**Karridale Mansions : fire and safety issues : Camden 2024/0182/P**

I recently came across your planning application submission for Karridale Mansions at 72 Tottenham Court Rd W1T 2HE, planning submission number 2024/0182/P on Camden's Planning Portal<sup>1</sup>.

Flat 10 distorted frames April 2021; "maintenance work" 18 September 2023; window status since 19 September 2023

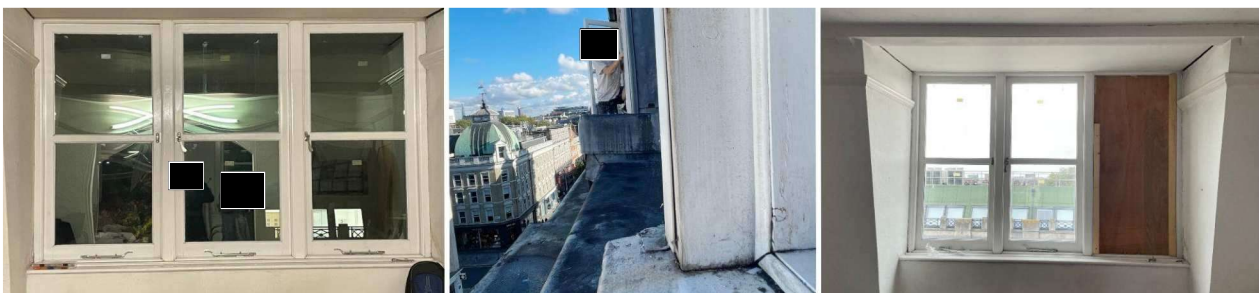
Firstly, for context, I agree that the windows in the building need attention. At present several of our windows have severely distorted frames, as shown below, and one of the windows has been boarded up for 12 months. The landlord's maintenance (which was aborted) leaves a lot to be desired.
